## Staff Report to the Zoning Administrator

Application Number: **04-0514**

**Project Description:** Proposal to reconstruct a single-family dwelling destroyed by fire. The project requires a Variance and Riparian Exception to reduce the required 30-foot front yard setback to 10 feet, and to develop within the Riparian Corridor.

C O U N T Y O F S A N T A C R U Z  
D I S C R E T I O N A R Y A P P L I C A T I O N C O M M E N T S

FIGURE NO. 3

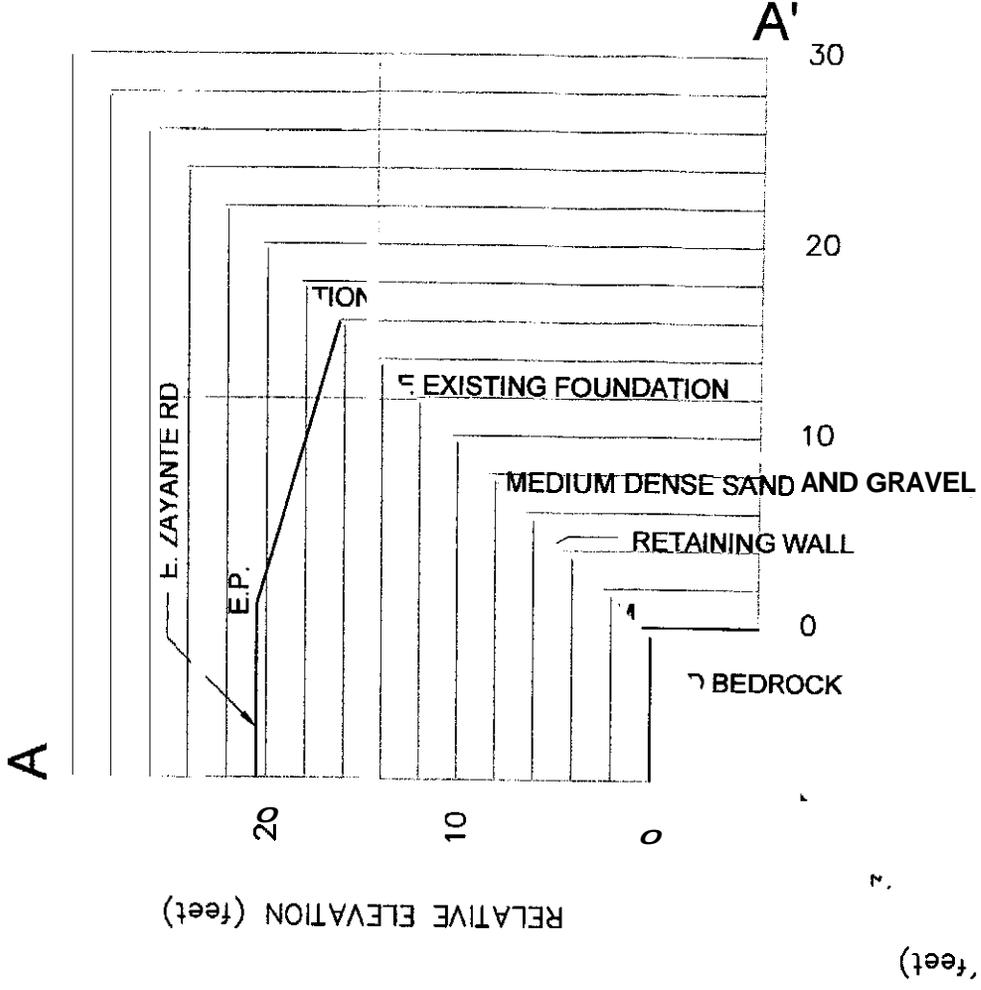
**Comment #2**

Provide a cross-section that shows the depth to bedrock, the depth of the proposed piers, the location of the house, the existing retaining walls, and the stream

**Comment #3**

Establish and indicate on the plans a setback line from the Creek for proposed improvements such as the Fire department turn-around and the underground utilities. The intent of this setback is to qualitatively compensate for stream erosion and other potential stream embankment instability.

Cross-section B-B' was shot through the proposed parking area to aid in our assessment. In addition one additional hand augered boring was advanced to verify soil conditions in this area. It is our understanding that a Fire Department turn around is not required because the residence is so proximate to East Zayante Road.

But, it is recommended that utility lines be setback from the creek. This is shown on the cross-section. The proposed parking area is setback an appropriate distance from the creek based on the 31 March 2005 plot plan by Larry Rothfuss, project designer.
